STAFF REPORT TO COUNCIL

FILE NO: 3360-20-RZ19-02

SUBJECT: LOT 16 MARINE DRIVE

REPORT NO: 21- 109

FIGURE 1 – preliminary on- and off-site servicing costs for proposed Lot 16 development

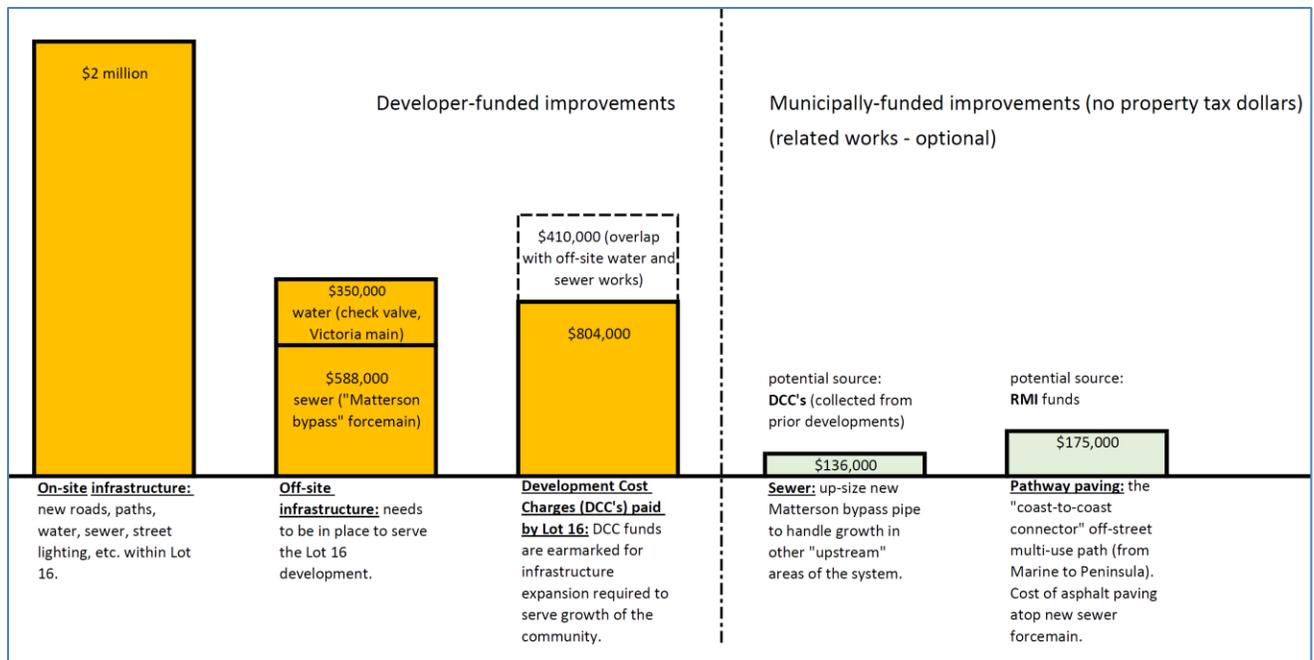
A number of comments from the public raised concerns about the impact on existing infrastructure (such as the Victoria Road sewer pump station), the cost of installing new infrastructure - and questioned whether Ucluelet taxpayers would be bearing those costs. These are good questions. Briefly, in response to questions “e” and “j” of the Council motion above, consider the following:

- the total servicing costs borne by the developer – in approximate numbers at this point - amount to \$3.7 million (the orange areas in the chart in **Figure 1**);

- note that there is an overlap identified between off-site infrastructure and works already defined in the municipal DCC program amounting to \$410,000. If the off-site works are constructed as proposed then that portion of the DCC's would not be charged to the developer – because doing otherwise would amount to double-charging (shown as the dashed line in **Figure 1**).
- as noted in the March 23, 2021, staff report:

Note that both of these items are advisable to take advantage of cost savings during construction of the developer’s works - but are optional and could also be completed by the municipality at another time (though likely at greater cost). It is also worth noting that both of these items could be funded without relying on additional municipal property taxes (see green bars in Figure 1, below).

Area E - Townhome Concept

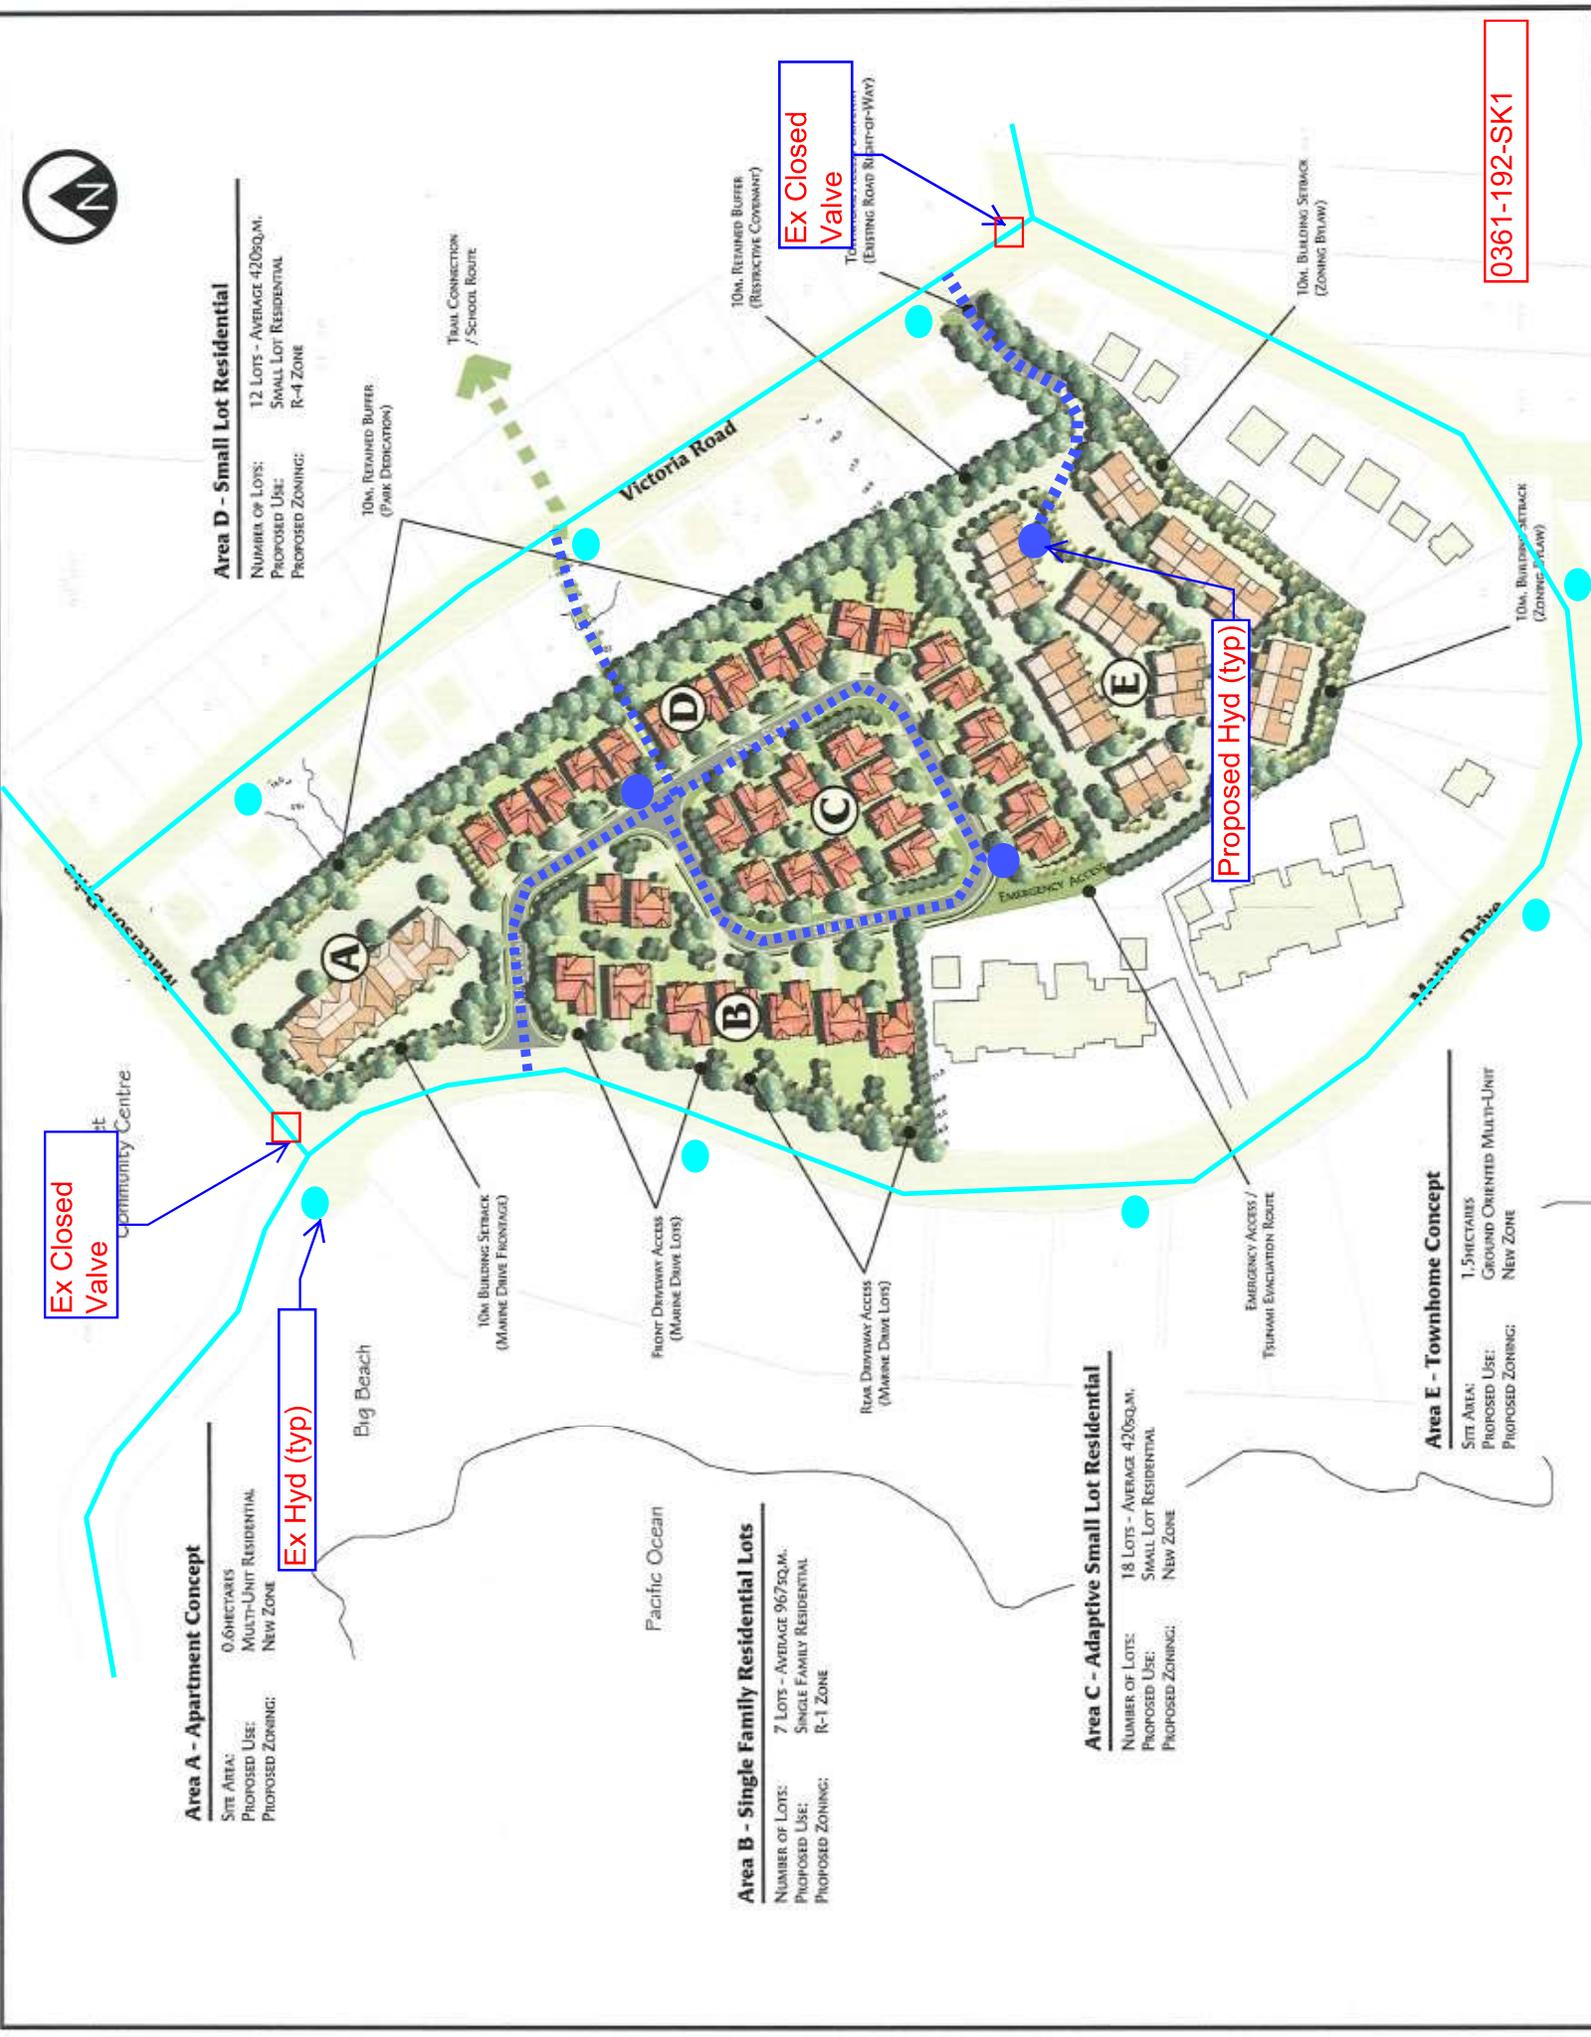
As shown in the above tables the proposed improvement option 3 is required to provide the required fire flows under and peak hour pressure existing conditions. It should be noted that 90 lps is not available at the proposed onsite hydrant at Area E.

- 1) The onsite piping be sized as per the attached figures.
- 2) The required fire flow for the development should be validated using the Fire Underwriters Survey document Water Supply for Fire Protection (1999) when the architectural plans are known.
- 3) Install all works listed in Option 3 to provide the required fire flows and peak hour pressures.
- 4) Review the fire flow requirements for Area E.
